BROWNS FERRY NUCLEAR PLANT (BFN) - UNIT 3 - TECHNICAL SPECIFICATIONS (TS) CHANGE 445 - SAFETY LIMIT MINIMUM CRITICAL POWER RATIO (SLMCPR) - CYCLE 12 OPERATION - RESPONSE TO REQUEST FOR ADDITIONAL INFORMATION (RAI) (TAC NO. MC0918)

This letter is in response to the December 5, 2003, RAI regarding BFN TS change request 445. The proposed amendment, which was submitted October 1, 2003, revises the numeric value of SLMCPR in TS 2.1.1.2 for one and two recirculation loop operation to incorporate the results of the Unit 3 Cycle 12 core reload analysis. The SLMCPR values provided in TS-445 were determined by Framatome Advanced Nuclear Power (FANP) for TVA.

**Browns Ferry Nuclear Plant Unit 3
TS-445 Request for Additional Information
Responses**

Figure A.6 Overall SLMCPR Analysis
Flow Chart

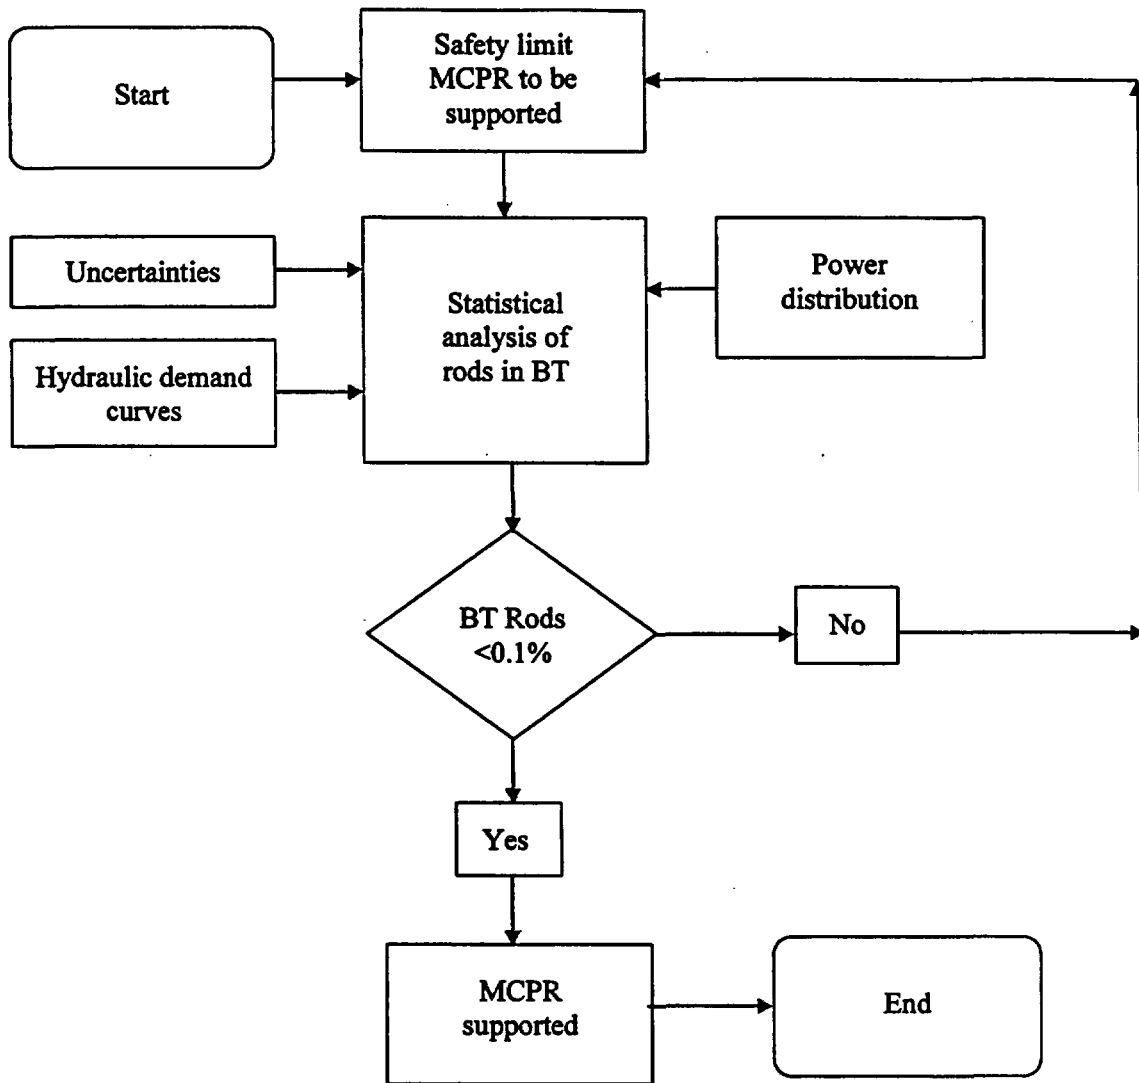
Provide a flow chart including input parameters to describe the analysis done for the safety limit minimum critical power ratio (SLMCPR) in the mixed core configuration. Also, identify the approved methodologies used in this analysis and justify their applicability to the SLMCPR analysis for Cycle 12 operation. Please address the technical position and limitations, and conditions in the staff Safety Evaluation Report stated in ANF-524(P)(A) Revision 2 and ANF-524(P)(A) Supplements 1 and 2, EMF-2209(P)(A) Revision 1, and EMF-2158(P)(A), Revision 0.

An overall SLMCPR analysis flow chart is presented in Figure A.6. The statistical analysis portion of that figure is detailed in Figure A.7. The flow charts are consistent with the presentation and description in Reference A.1.
